BOARD ACTION REPORT – APPEALABLE ITEM

Project Name: SE 2nd Avenue Parking Lot
Project Location: 215 & 219 SE 2nd Avenue
Request: Extension Request for a Class V Site Plan, Landscape Plan and Associated Waivers

Board: Site Plan Review and Appearance Board
Meeting Date: August 10, 2016

ITEM: SE 2nd Avenue Parking Lot – Class V Site Plan associated with construction of a fourteen (14) space public parking lot with associated infrastructure, lighting and landscaping enhancements

PARKING LOT SITE PLAN

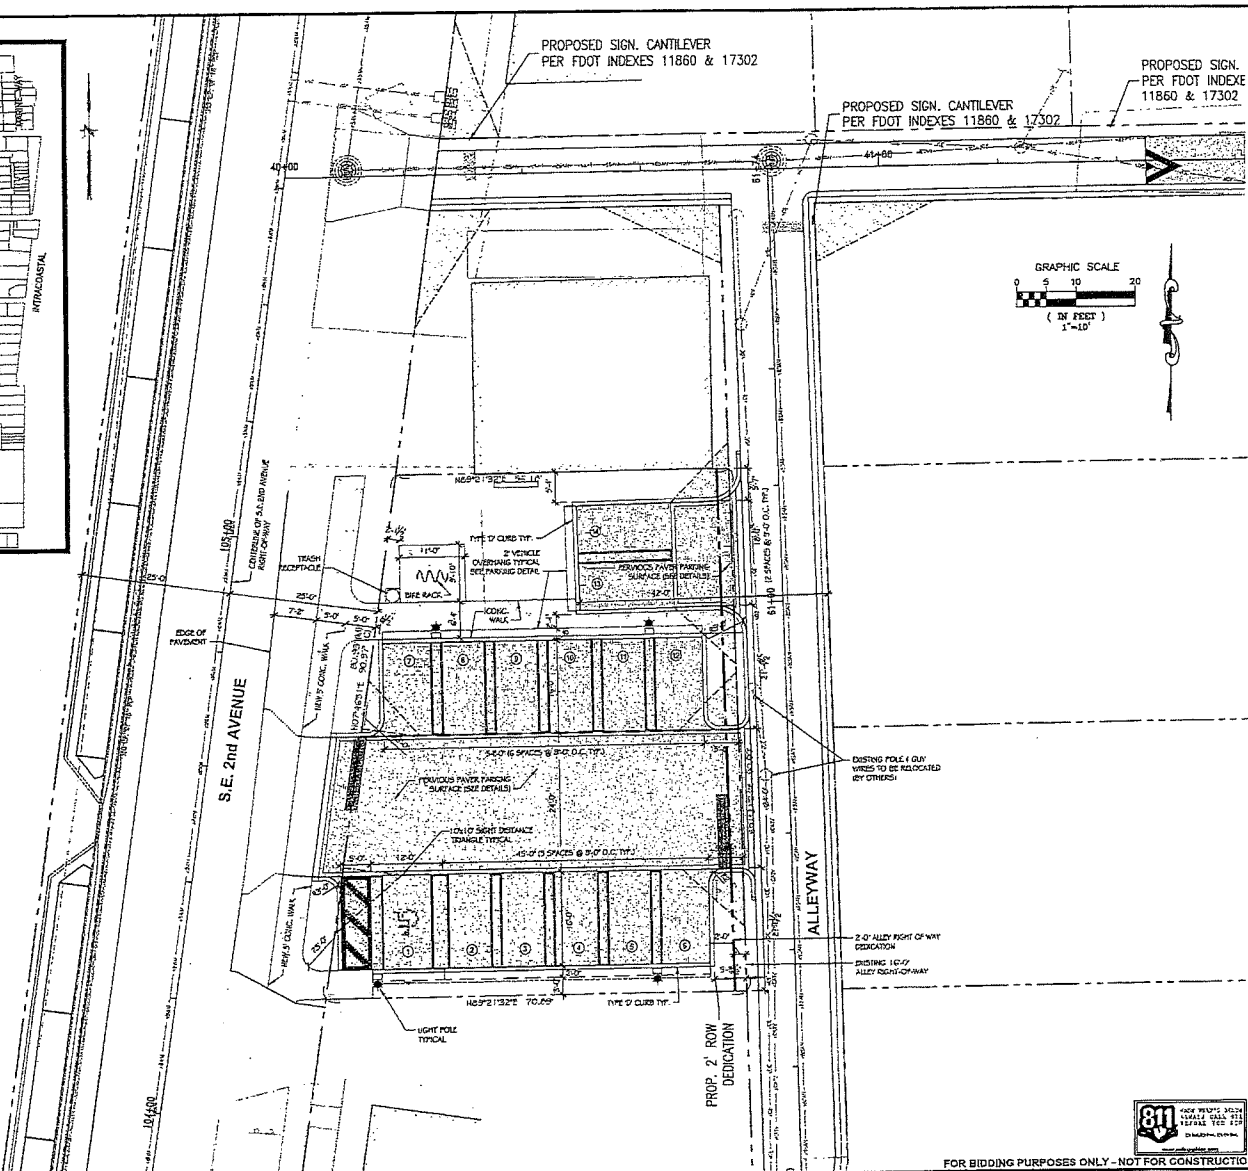
Additionally, while no relief is required, the plans do not reflect compliance with LDR Section 4.6.9(D)(2)(b) with respect to the 10' wide parking stall required when parking spaces back out onto an alley. Currently, plans reflect the standard 9' parking stall widths for the proposed 2 spaces which back out onto the alley. Whereas, the stall width is 18' for the 2 spaces and 20' is required. The provision of the additional width will not adversely affect any aspect of the development proposal and LDR requirements will be satisfactorily met. The City Engineer has agreed to make these changes in the field such that plan revisions are not deemed necessary. Staff supports this correction method and these changes will be verified in the field prior to building permit issuance.

4. Revise the location map on the site plan (Sheet SP101) for consistency with LDR Section 2.4.3(A)(4), to clearly depict the location within the vicinity of a one-half mile radius. The exact location cannot be determined from the location map currently provided.

5. Along SE 2nd Avenue, the site plan shall dimension the adjacent right-of-way from the center line.
6. Label and graphically depict the proposed five foot (5') sidewalk along SE 2nd Avenue on all plans.
